TRIMABLE OUTPUT STAGES

SIZE	DRAWING NUMBER	REV
D	92-1156	E
6-9-2004_15:13		SHEET 3 OF 3

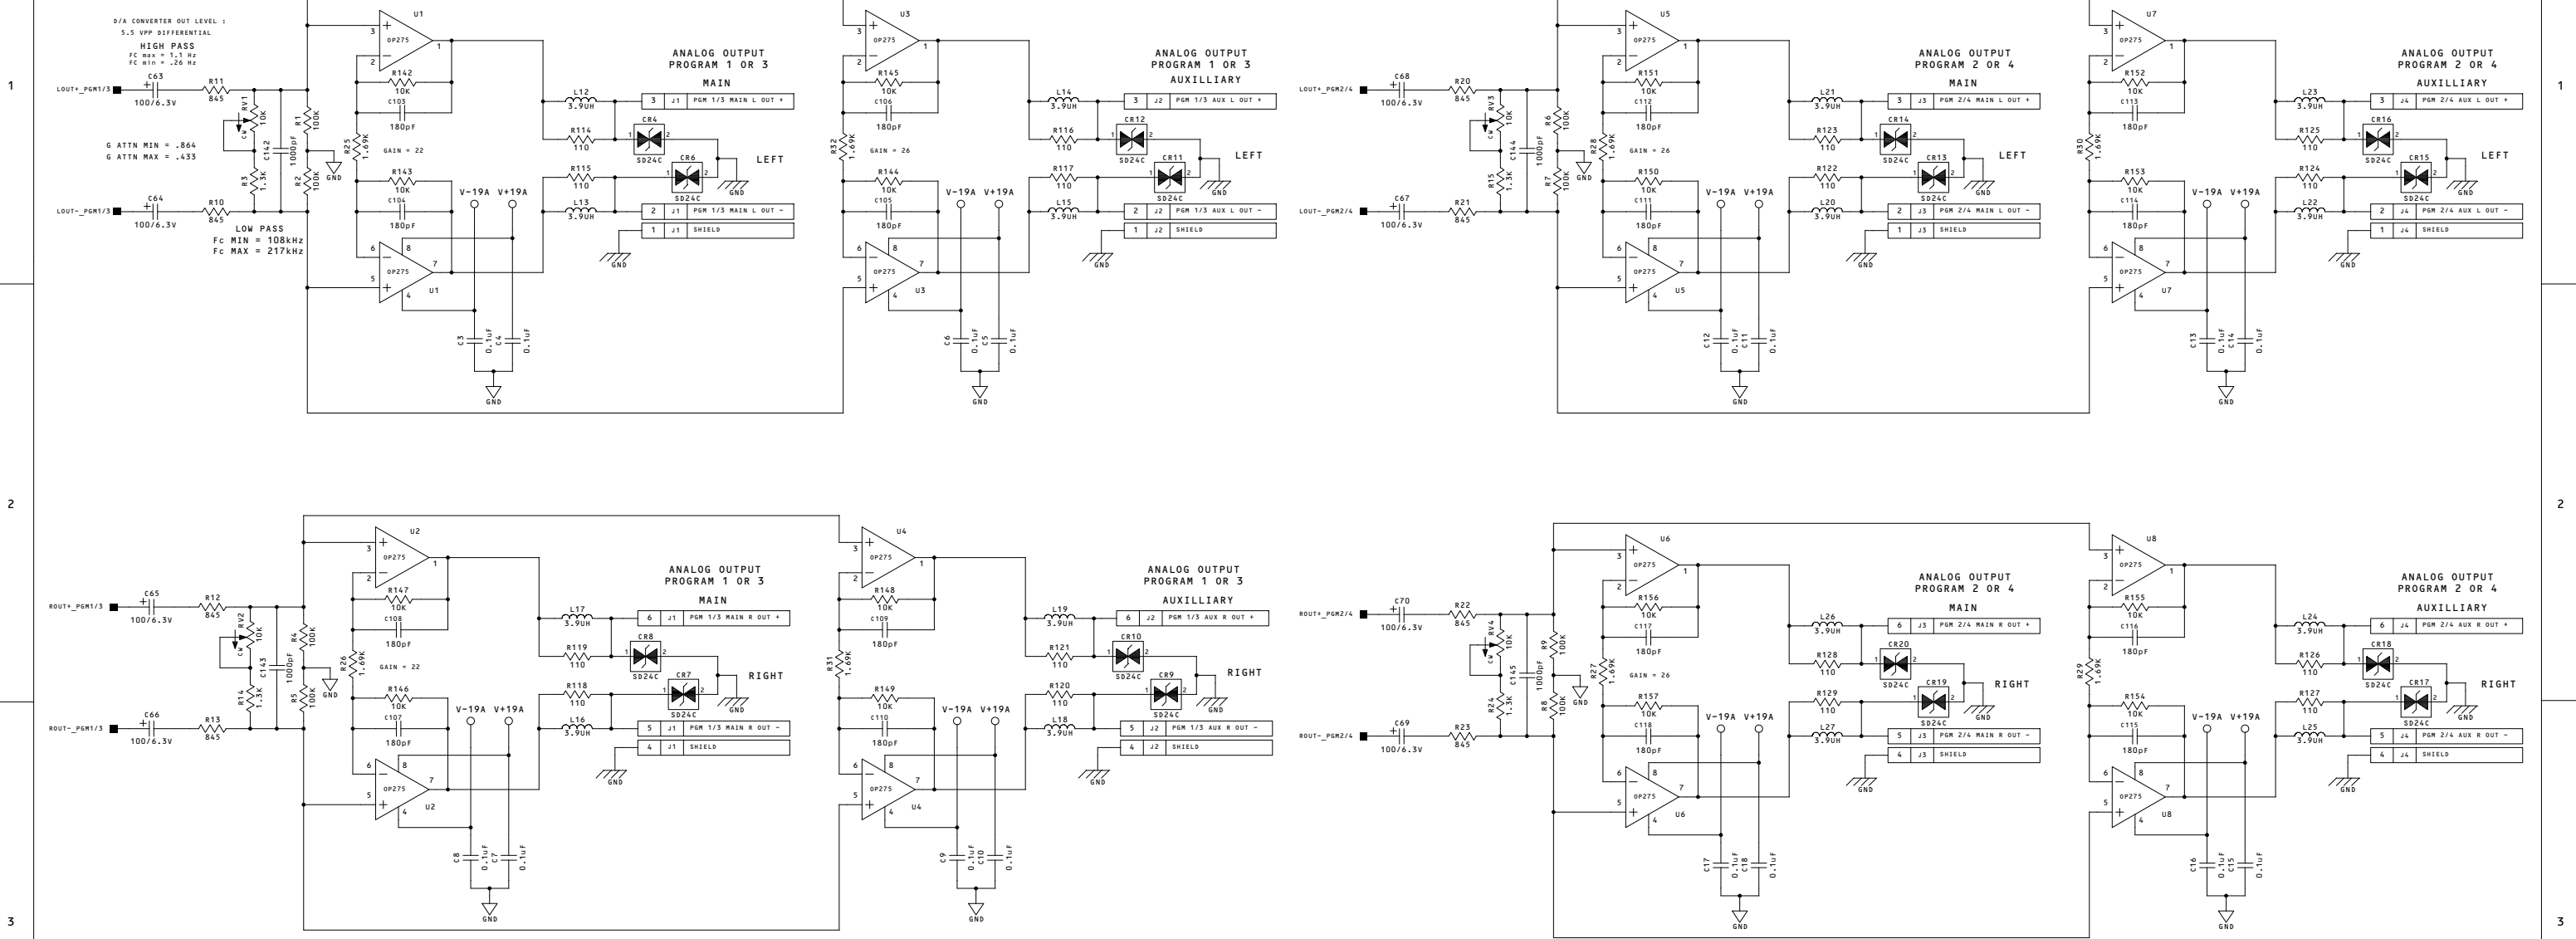
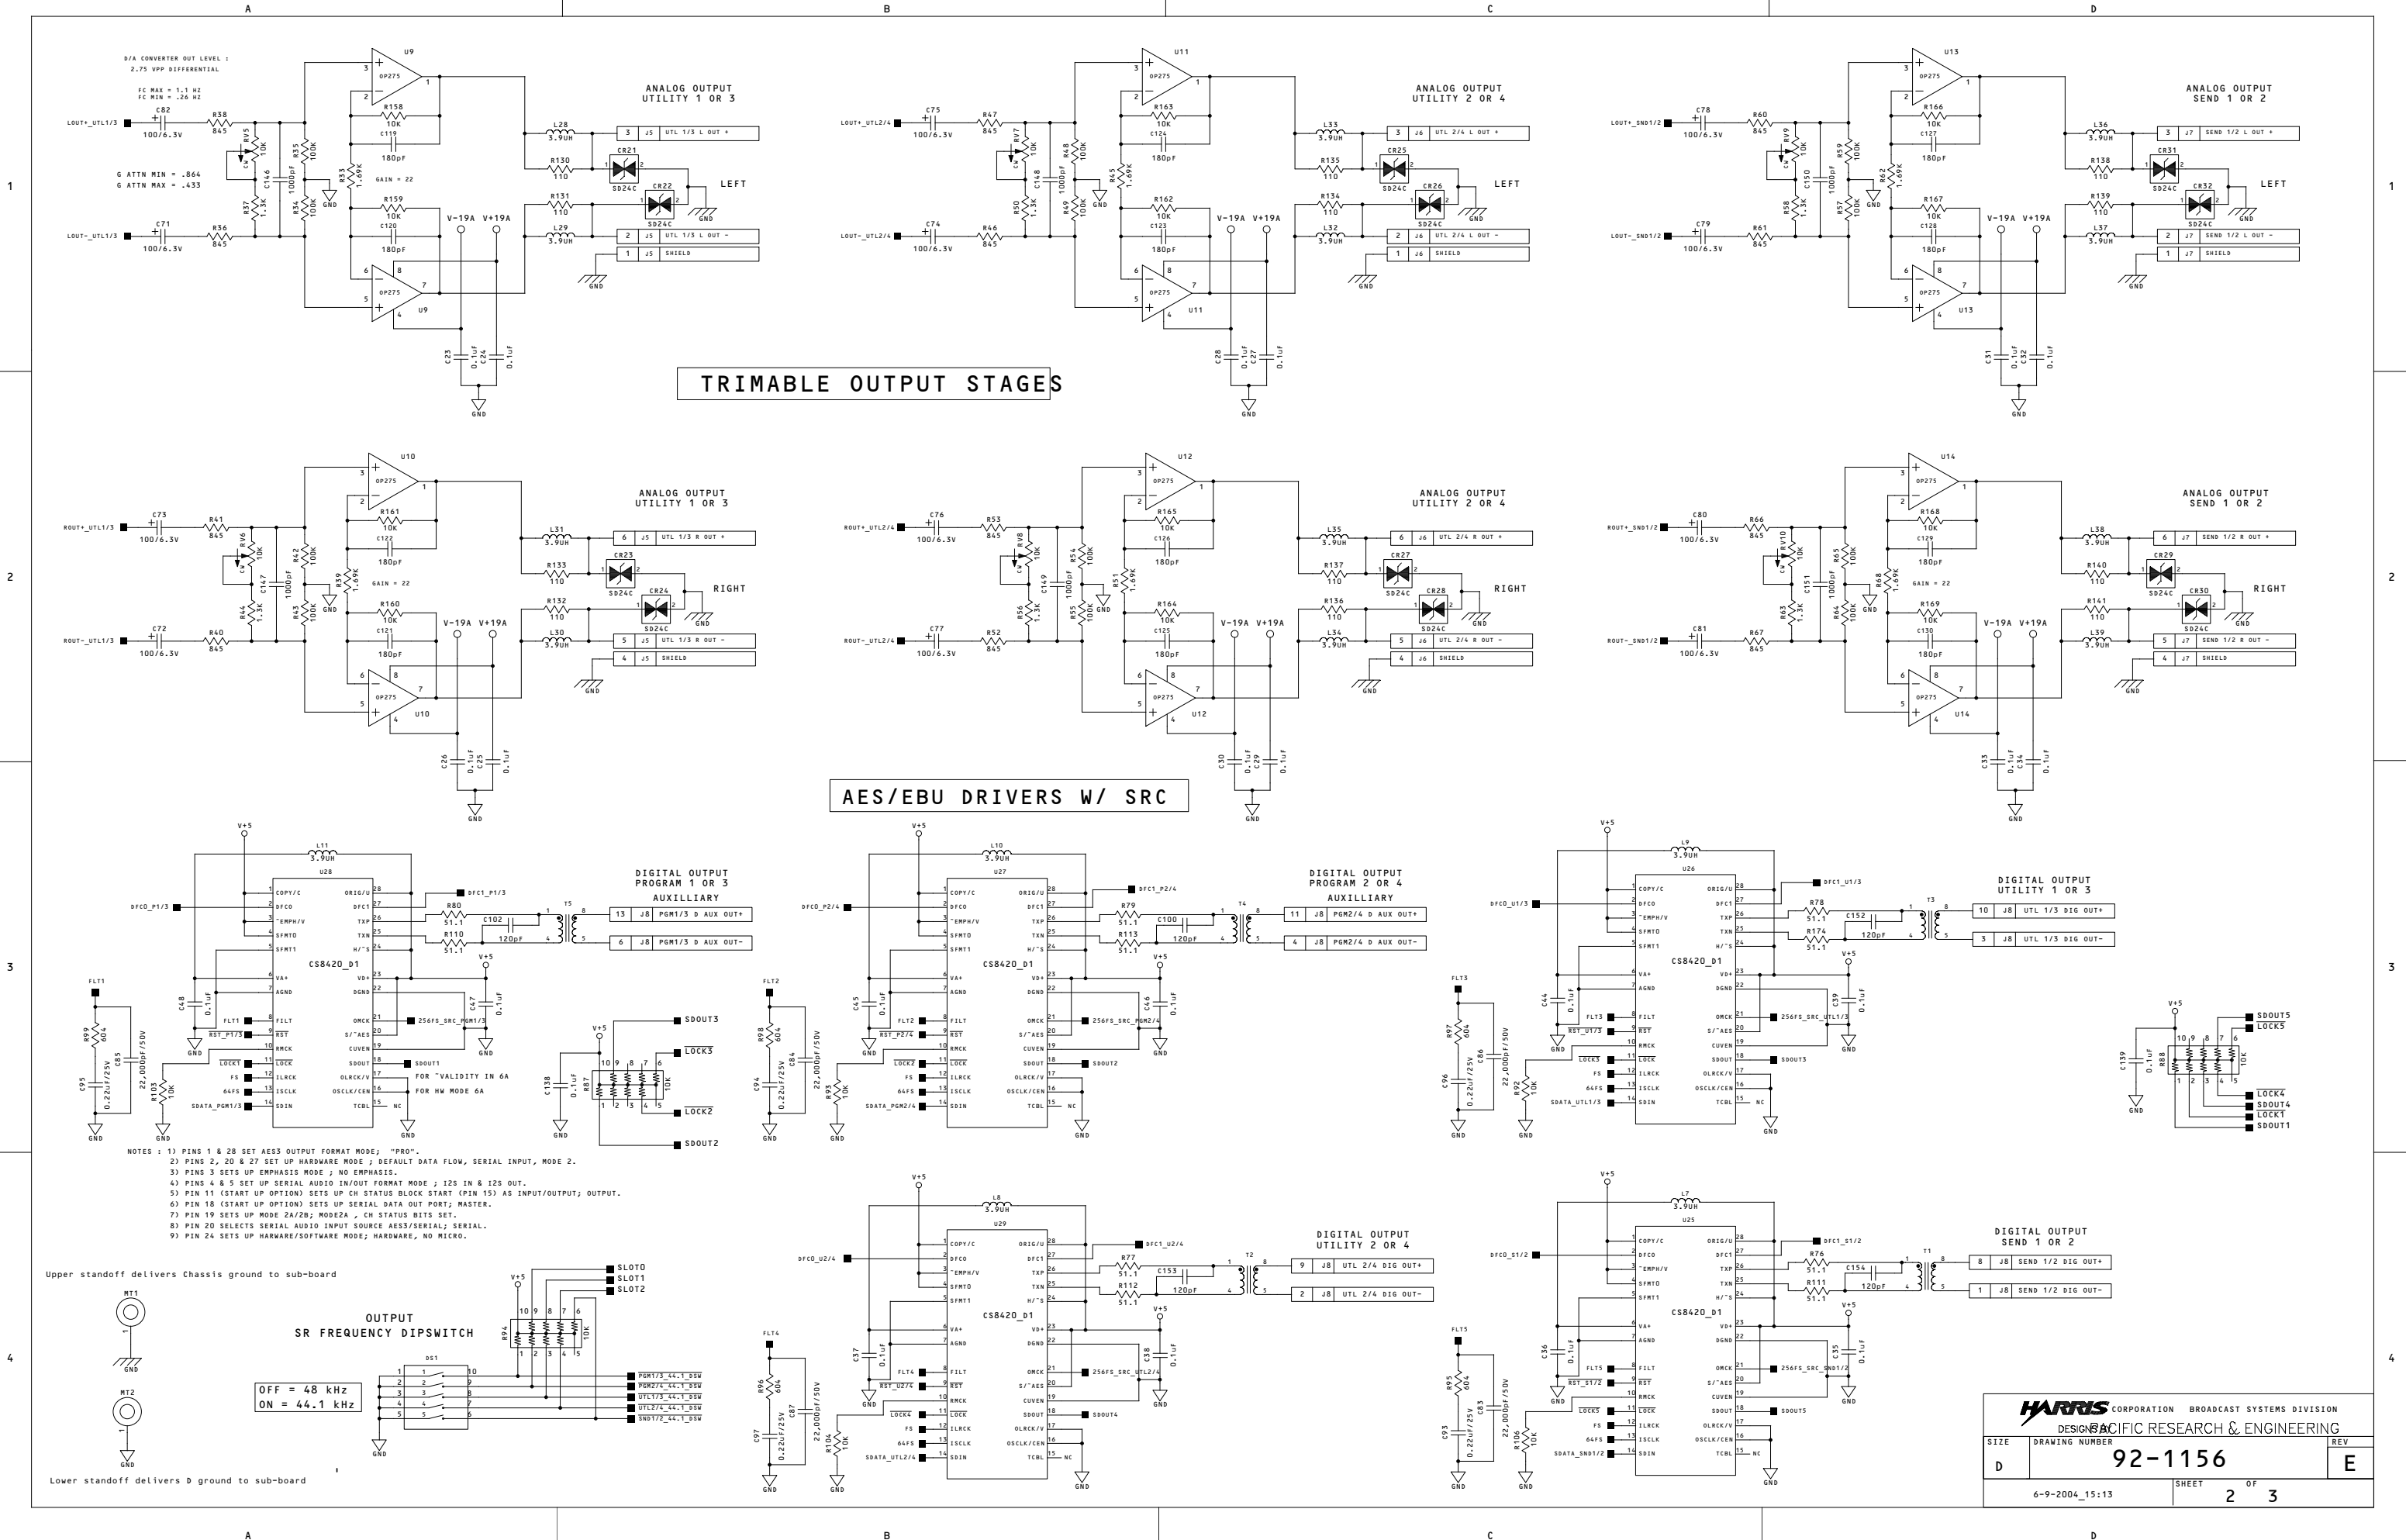
Changes Rev. C to Rev. D

Page 3 Zone C3  
Delete Qty. 2, 62-50 (Cap, 18pF), C131,132  
Add Qty. 2, 62-41 (Cap, 33pF), C131,132  
Delete Qty. 1, 2-283 (Res, 10M), R75  
Add Qty. 1, 6-280 (Res, 1M), R75
